# ***SERVICE PROCEDURE***

**13520  
FEBRUARY 2014**

**SUBJECT: NON-COMPLIANCE RECALL**  
Driver and / or passenger seat belt buckle on certain CE and RE school bus models built 8 August 2013 thru 14 November 2013 having certain IMMI seat belt assemblies with L9 end-release seat belt buckles

Certain IMMI seat belt assemblies with L9 end-release seat belt buckles may fail to conform to the requirements of Federal Motor Vehicle Safety Standard No. 209 "Seat Restraint Systems."

FIG 1

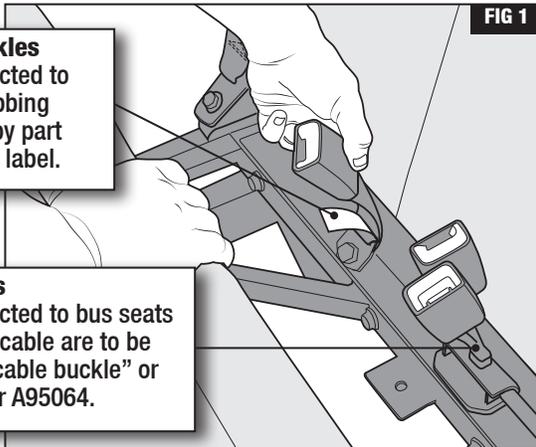
2. Identify buckle type for any buckles that fall within the suspect date code range.
3. **IF** you have buckles that fall into the date code range, then please gather buckle part numbers (FIG 1) and total quantities for ordering replacement buckles from IMMI.

FIG 2

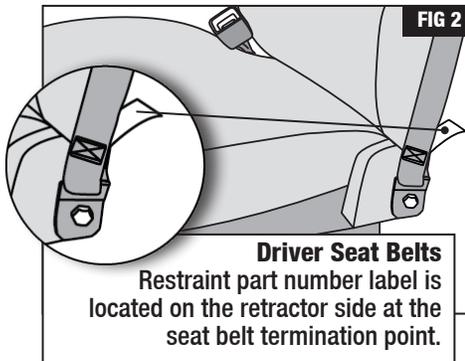
1. Inspect date code on back of driver buckle on identified vehicles. See instructions on the right.
2. Note restraint part number for any buckles that fall within suspect date code range.
3. **IF** you have buckles that fall into the date code range, then gather restraint part numbers (FIG 2) and total quantities for ordering replacement buckles from IMMI.

FIG 3

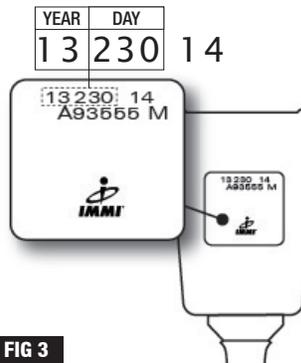
Suspect code range is  
**13220 through 13256**

5. If your buckle code is within either of the ranges above, follow instructions to order, then replace the buckle.
6. If your code does NOT fall within either range, you do NOT need to replace your buckle.

FIG 4

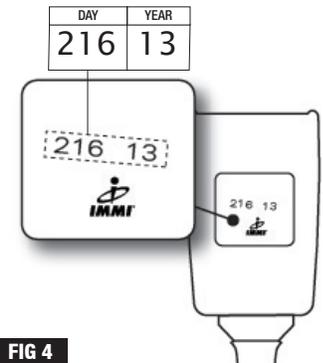
Suspect code range is  
**214 13 through 256 13**
